ADDENDUM NO. 07

Date: 08.23.2024

**Westfield Washington School Corporation
Westfield Middle School West
Bid Package 02, BI:02 Building Concrete Work and BI:03 Steel and Railing Work
17707 Centennial Road,
Westfield, IN. 46074**

The Hagerman, Inc portion of this Addendum consists of the following information:

DRAWING TITLE:
SECOND FLOOR & LOW ROOF FRAMING PLAN - UNIT G

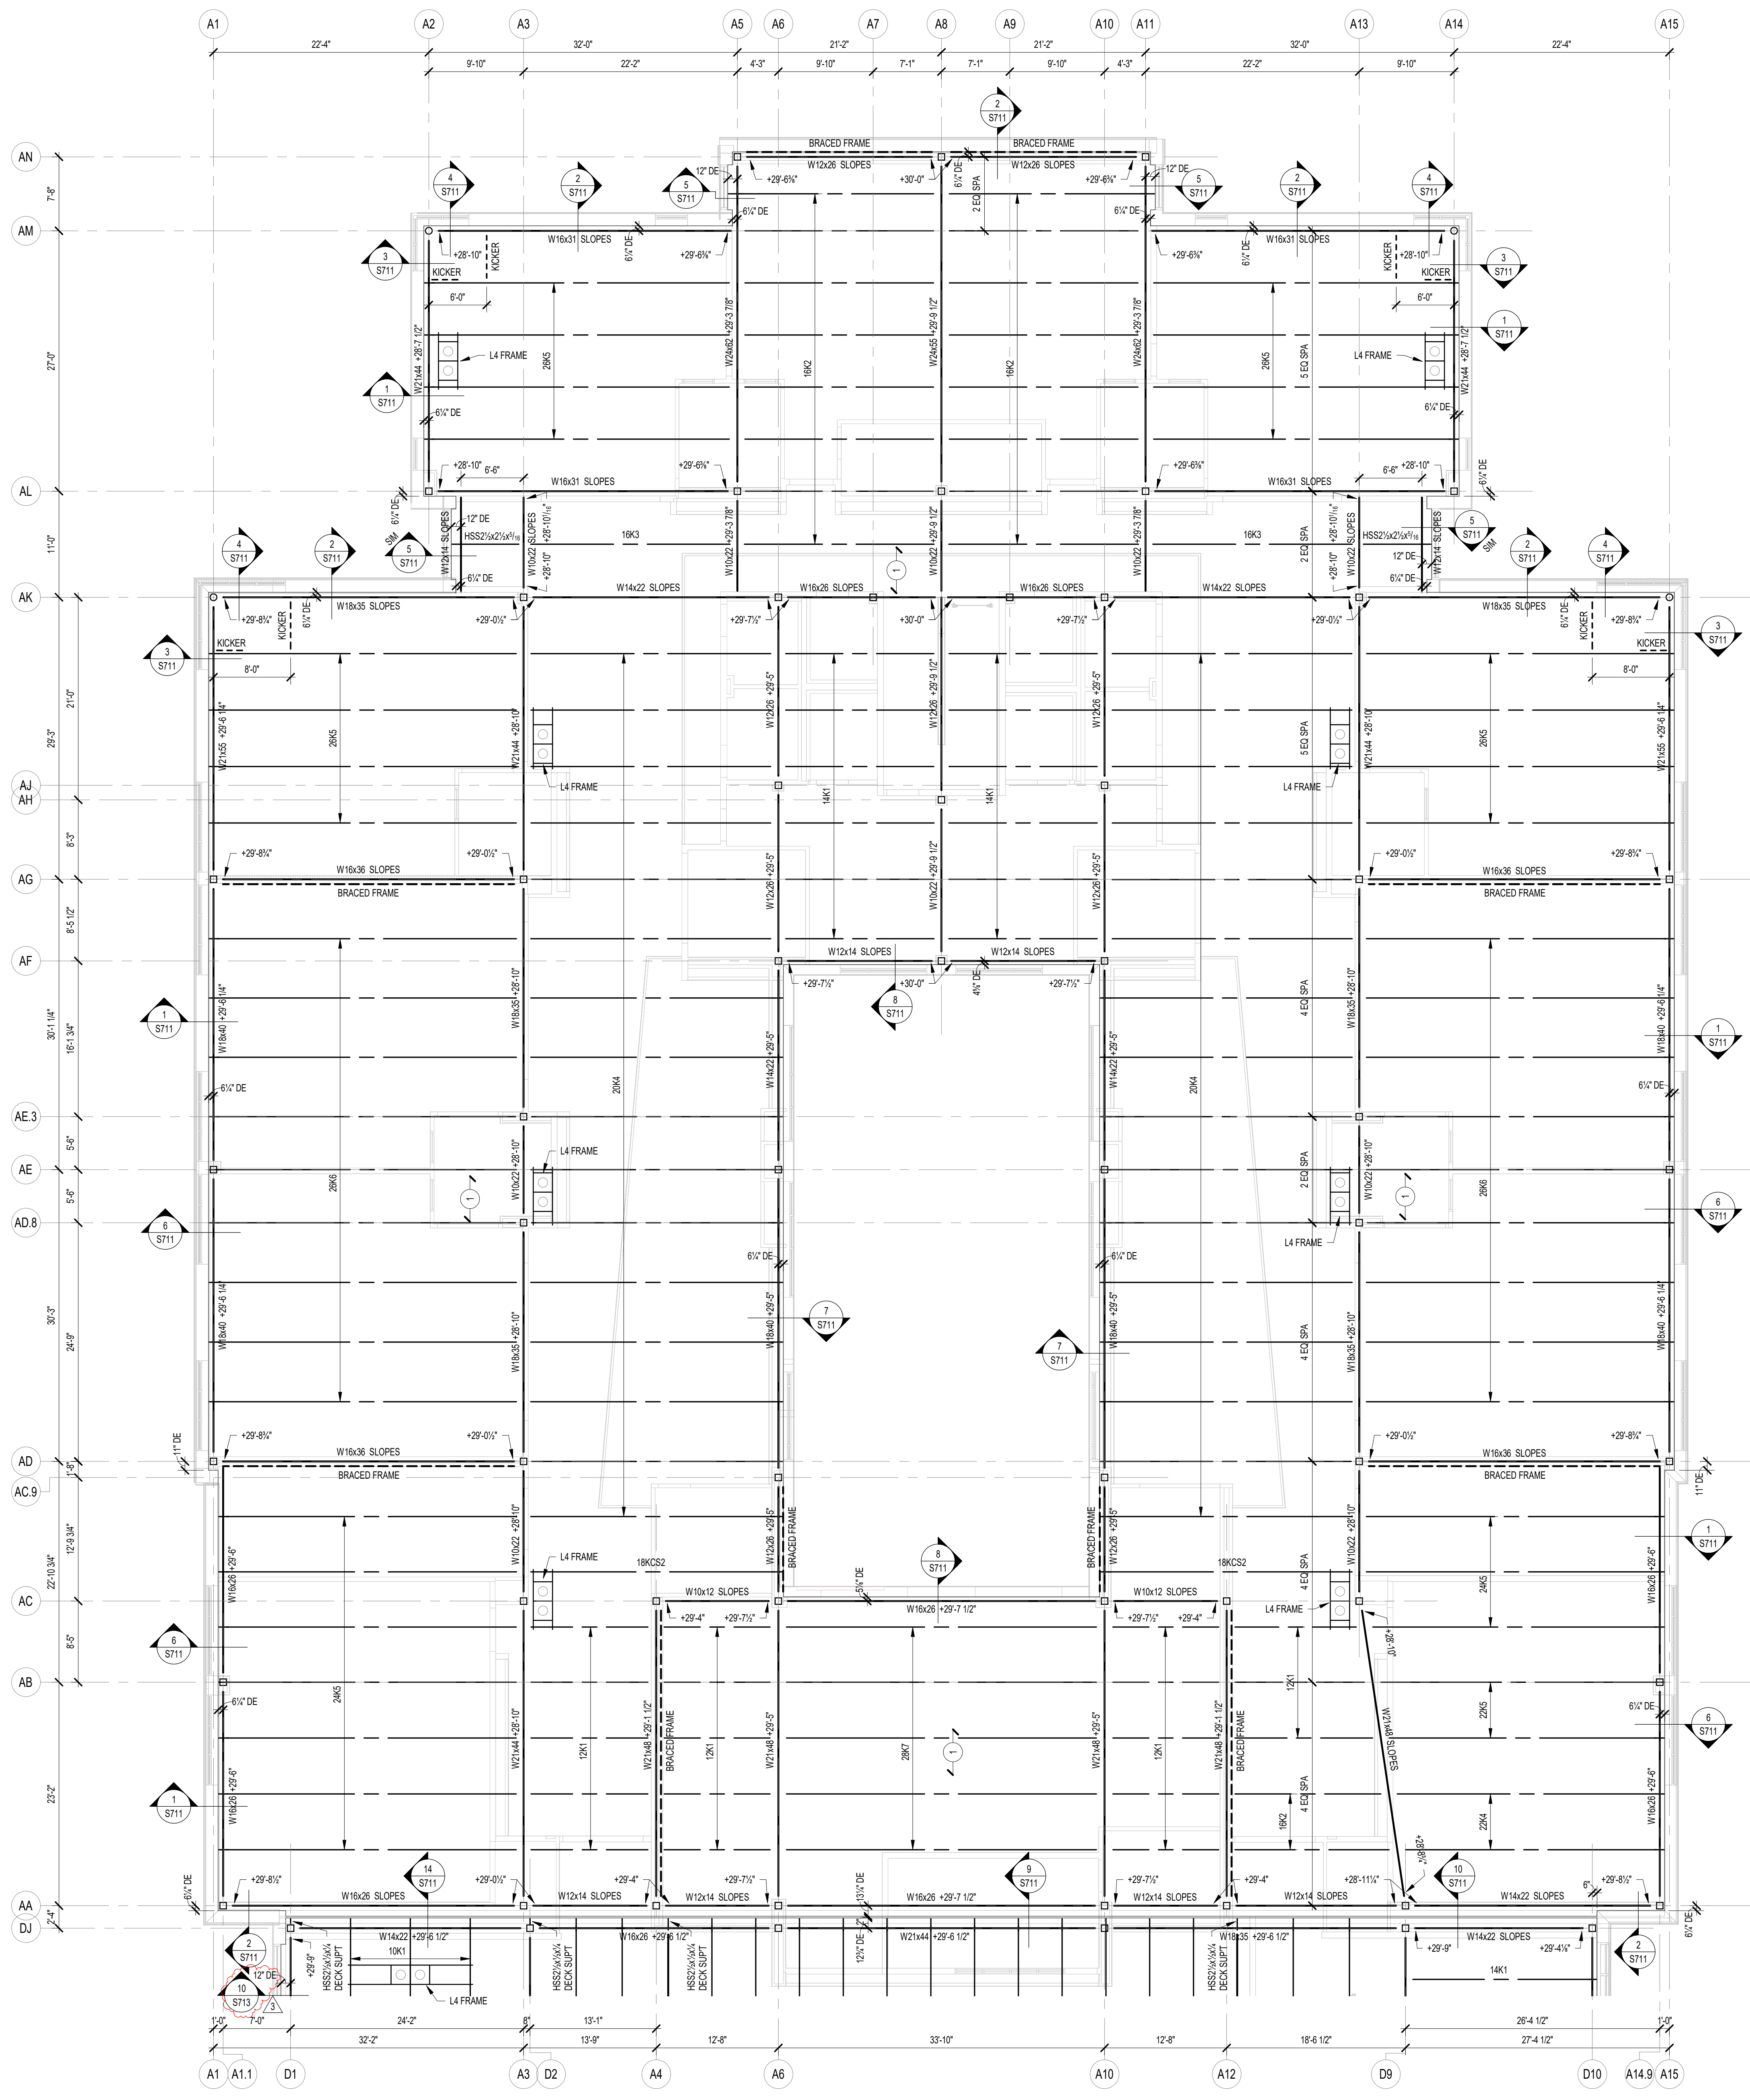
- A. Add floor opening frames as shown.
